Interactive comment on “Numerical Simulations of the 2004 Indian Ocean Tsunami Deposits Thicknesses and Emplacements” by Syamsidik et al.

Received and published: 8 March 2019

Fig. 1. Accumulative sedimentation and erosion at Birek, Pasi Janeng, Jantang, and Saney. Negative values represent erosion and positive values represent sedimentation thicknesses.

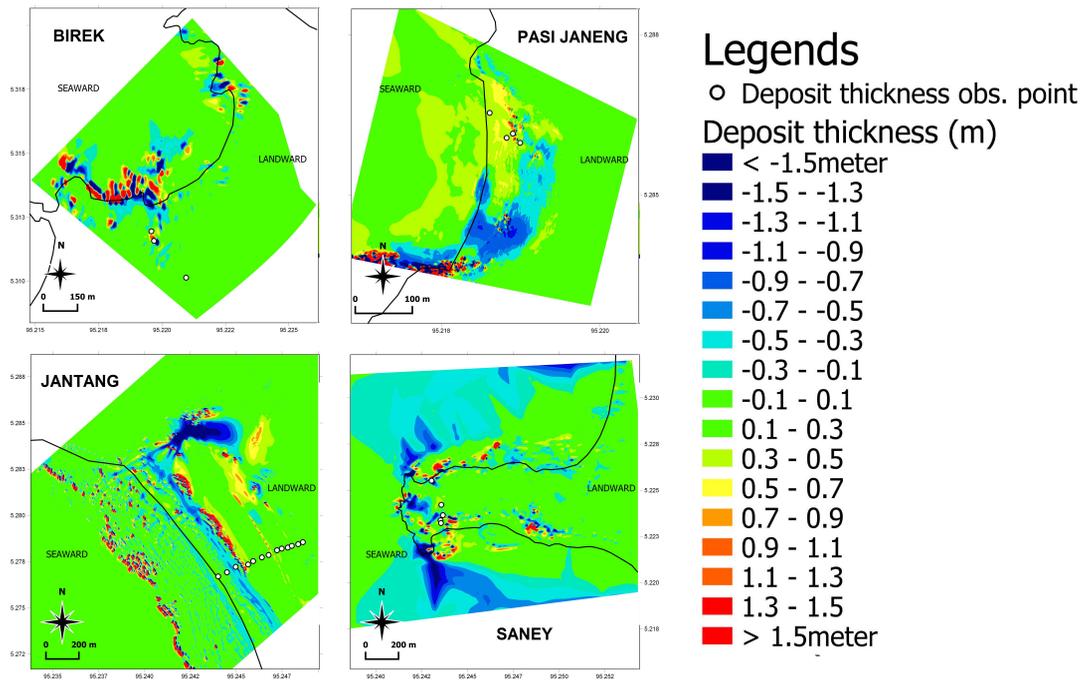
Thank you for the efforts to understand the process of sediment accumulation by the tsunami a decade ago. The following are more detailed comment for the improvement of the paper 1. Fig. 15-18 are not readable

RESPONSE 1: Thank you for your appreciation on our research. Fig. 15-18 have been modified and increased their resolutions to make it more readable. Combining Comments we received from other Referees, we have joined Fig. 15-18 and place them into one figure. Please see Fig. 1 of this response. The figure will replace Figs. 15-18. Furthermore, after being suggested to run more models, we have simulated the sediment transport models in DELFT3D using Engelund-Hansen 1967, Meyer-Peter-Mueller 1948, and Soulsby 1997. The original result presented in our previous manuscript was based on van Rijn 1984. Complete explanation of the mathematical formulae of the sediment transport can be find at Delft Hydraulic (2009). More detailed explanation of the additional simulation results for the sediment transport formulae can be seen at our Responses to Referee #1.

Fig. 2. Topography condition of Birek, Pasi Janeng, and Sanej.

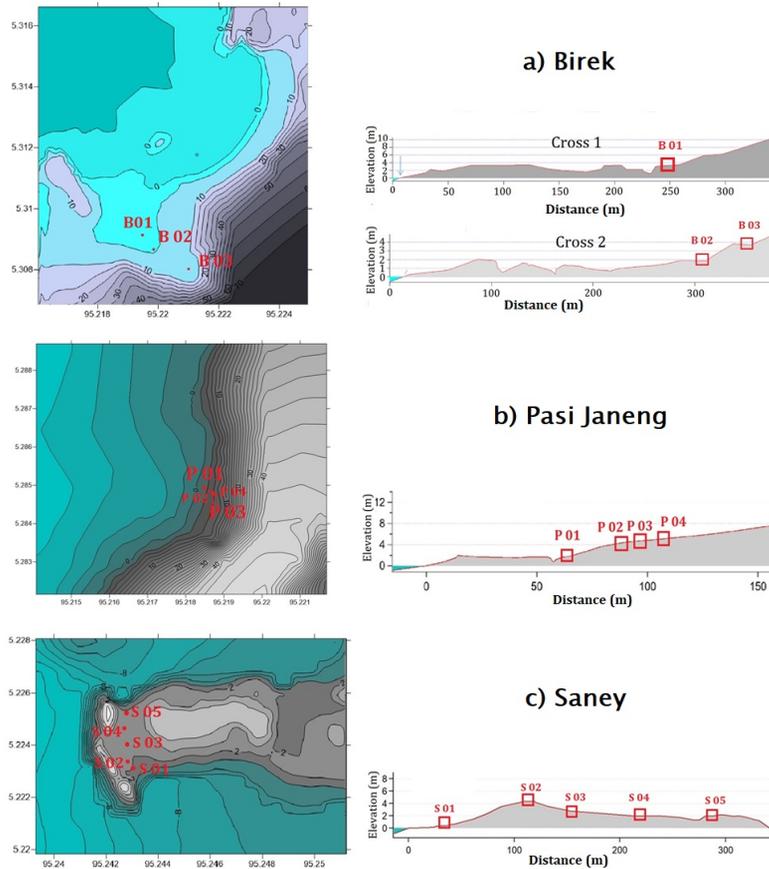
COMMENT 5: 5. Still in page 9, please define the steep and mild slopes discussed in this paper. In fig. 13, why the obs no. 2 and 3, after 09.00, the sediment accumulation keep increasing?

Here, we define the slope larger than 0.02 is steep and smaller than that was classified as mild. The topography condition at Birek can be seen at upper left part of Fig. 2 (part

of figures in this response) showing topography contour. As it can be inferred from Fig. 2 of this response or Fig. 13 in the previous version of our manuscript, the dense contour lines represent the steep slope of the area. Here, the slope of the area about 0.015 for the first 250 m from coastline (mild). Suddenly, after the point, the slope were between 0.05 until 0.1 (steep). The land area slope at Pasie Janeng was about 0.05 (steep). At Saney the slope of the land area was about 0.013 (mild). At Obs 2 and Obs 3, the sedimentation accumulation keep increasing due to weakening of shear stress generated by the tsunami waves after the second waves. The decrease of the shear stress drove the sediment to settle at the points. Similar explanation will be added into 4.4 Model Hindcast in our revised manuscript.
